AMENDMENT OF SOLICITATION/MODIFICATION OF CONTRACT

1. The specifications and drawings for Invitation No. DACW64-03-B-0006, Dredging, Middle Reach, Neches River Channel in Jefferson and Orange Counties, Texas, Sabine-Neches Waterway, Texas, advertised 20 December 2002 and for which bids are scheduled to be opened 21 January 2003, are hereby modified as follows:

**SABINE-NECHES WATERWAY,
TEXAS, MIDDLE REACH, NECHES
RIVER CHANNEL IN JEFFERSON
AND ORANGE COUNTIES, TEXAS,
DREDGING**

TO BE ADDED TO SHEET 6 OF 44

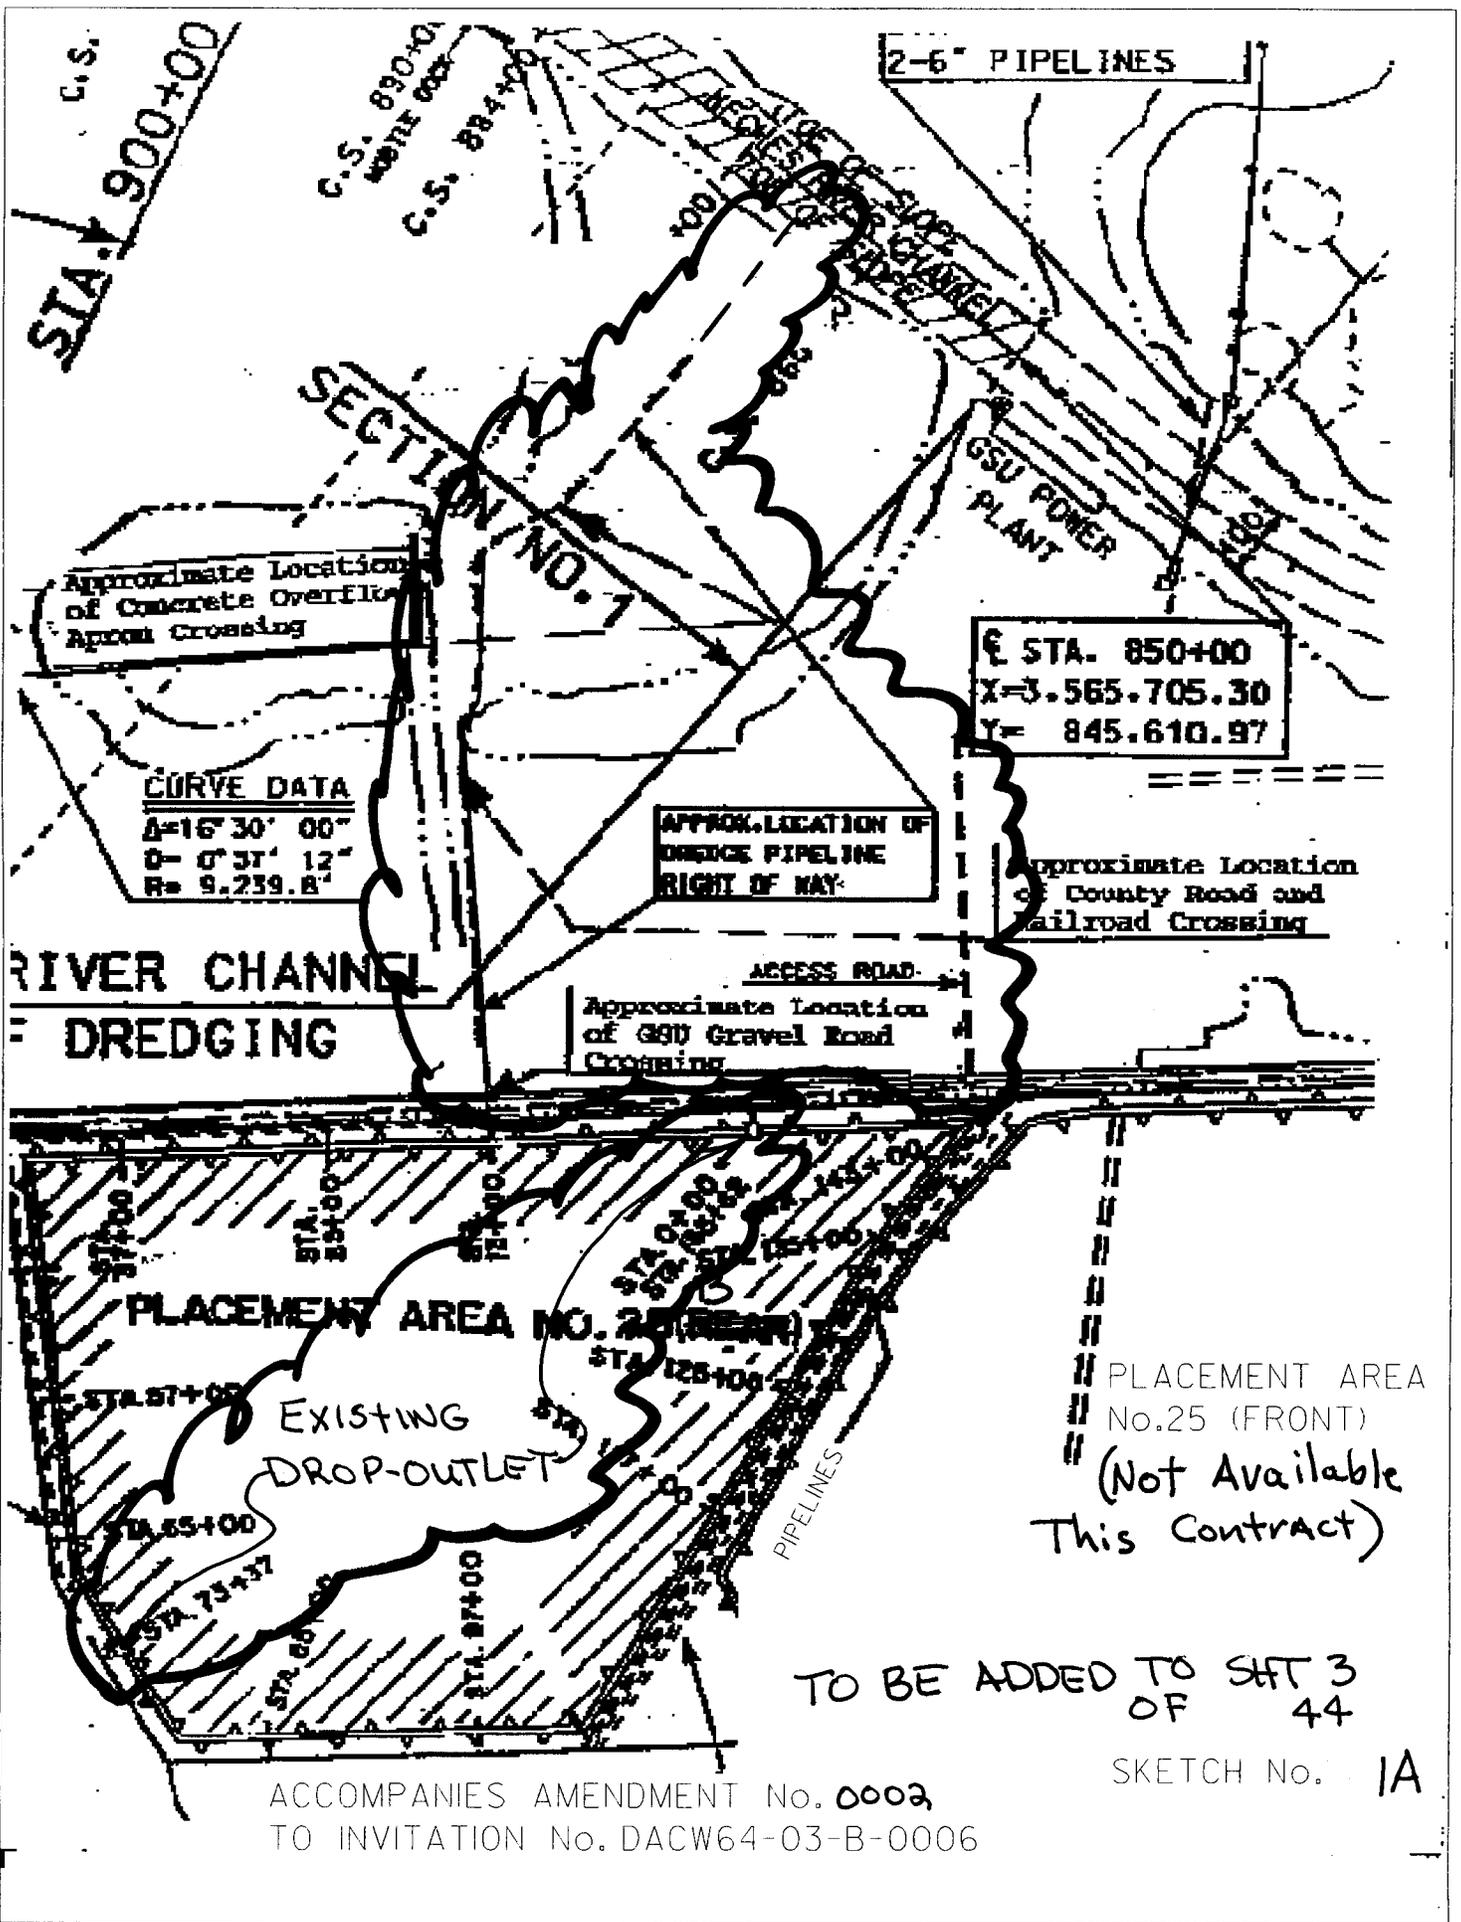
(2) Sheet 6 of 44. - The enclosed SKETCH NO. 1 showing the dredge pipeline route to Bessie Heights shall be added to and become part of Sheet 6 of 44.
